NUCLEAR REGULATORY COMMISSION

Title: Advisory Committee on Reactor Safeguards
 Reliability and Probabilistic Risk Assessment

Date: Friday, April 24, 2015

ACRS Subcommittee briefing on HRA, 4/24/2015

Recommendation 1: Mapping between cognitive mechanisms and PIFs in the decision-trees

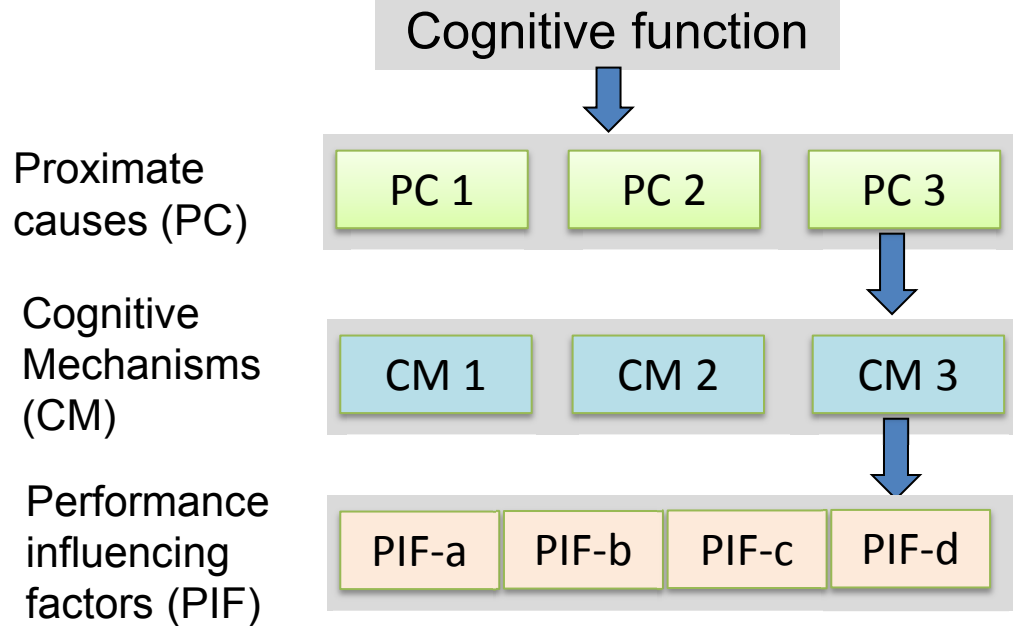
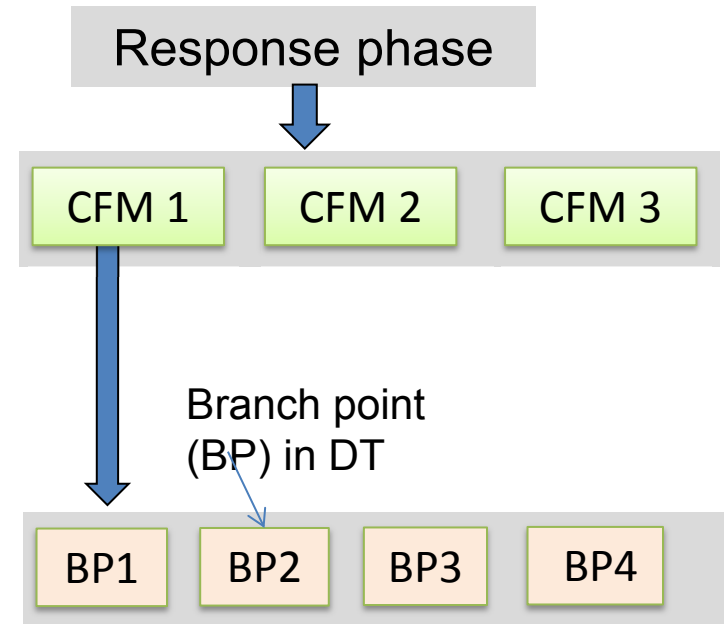
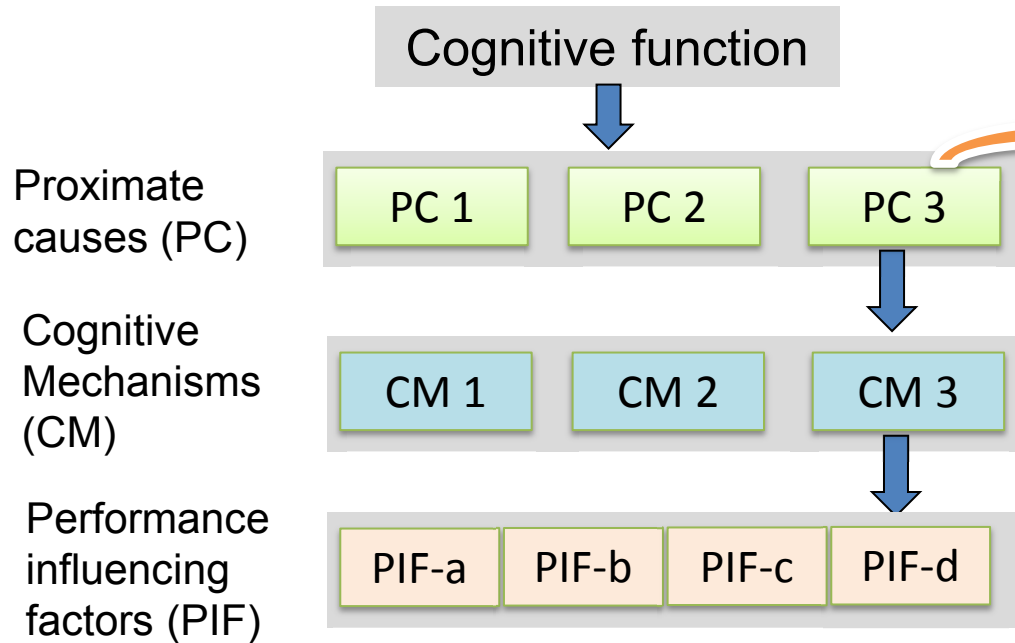
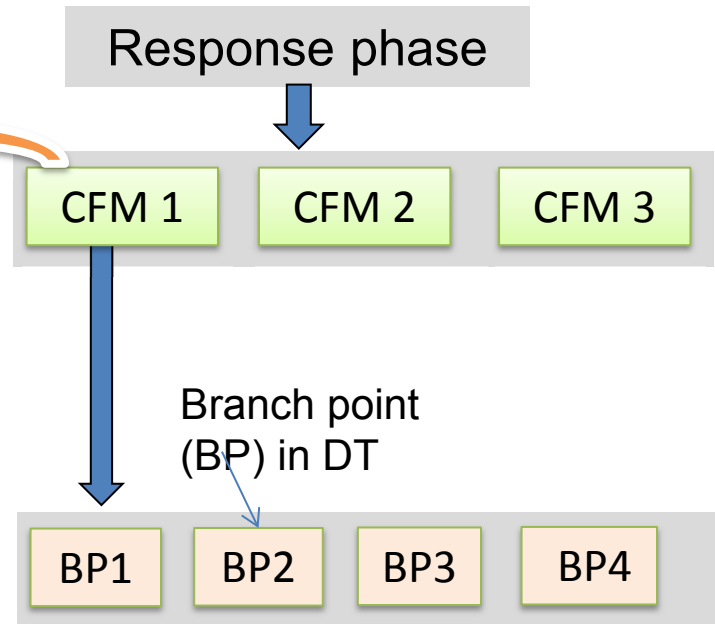
19 On the right is a structure of IDHEAS. IDHEAS
20 model, the first model is a response base which are
21 corresponding to the cognitive functions. And for each
22 base we identify a set of cognitive failure mode. And
23 for each cognitive failure mode we have a set of --- which
24 I wrote here is the branch point, the PIF factors there.
25 So, ideally, if we model all the possible failures then

1 every cognitive mechanism and PIF on the left column,
2 on the left side should be captured by the branch point
3 in the right side in the IDHEAS method. And realize that
4 some cognitive mechanisms may not be captured in the
5 IDHEAS method. That's what ACRS want we provide a
6 rationale why some of them were left out. So, we did a
7 mapping between these two side, and a good news to you
8 is most of the cognitive mechanism on the left were
9 captured by the branch points on the right side. And,
10 also, the PIFs. Well, the PIFs in the left I call the
11 A/B safety. Well, in the IDHEAS decision tree, the branch
12 point talk about the specific aspect of those. When you
13 talk training, there could be many different aspect of
14 training, like frequency of training, and whether you're
15 trained enough on malfunctions. And when we come to the
16 IDHEAS, we only capture the ones that are most relevant

Outcome: Mapping between every CFM /PIF and BPs

Two examples of ***a*** and ***k***

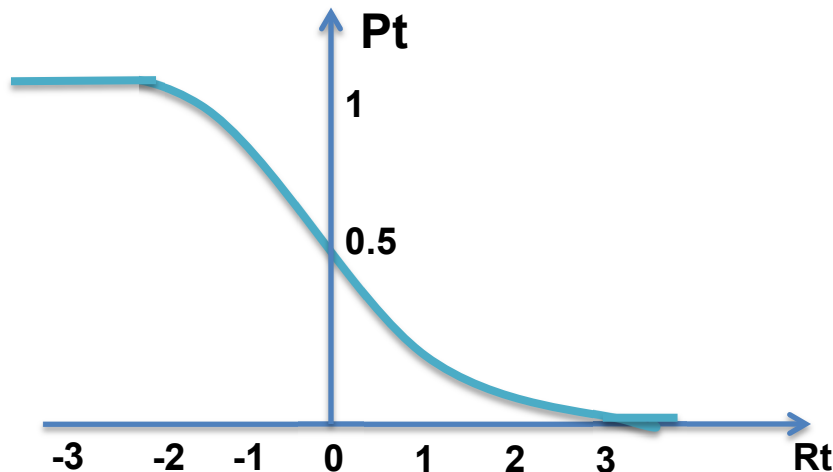
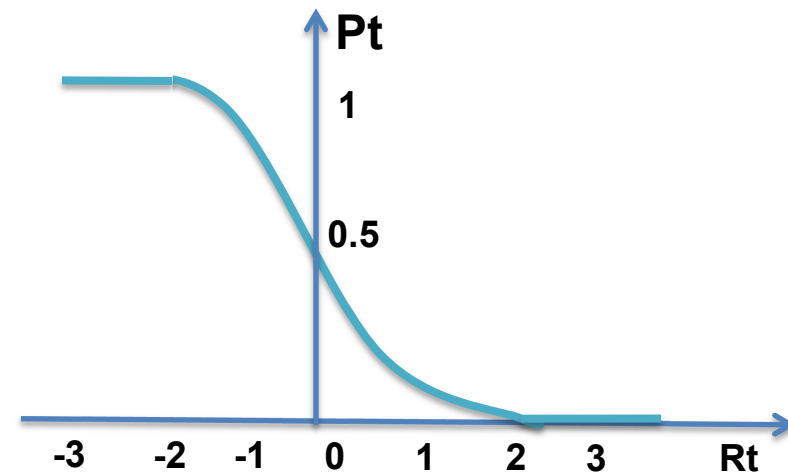
19 CHAIRMAN STETKAR: Not only is it absurd, but
20 the words are not correct, because the two distributions
21 are exactly the same breadth. And you say one is broader
22 than the other, and they're arbitrary. And that is the
23 quote that Dennis found that says "human reliability
24 analysts don't have the access to resources to estimate
25 times." If they don't, fire them. Find somebody who does.

1 CHAIRMAN STETKAR: Okay. Well, think of that,
2 abandon this, because this is just an arbitrary
3 mathematical framework with some assumptions that I
4 couldn't even figure out. And I don't know where you found
5 it, but it doesn't make any sense at all. And it's not
6 physical. If you have those two distributions, you can
7 ---
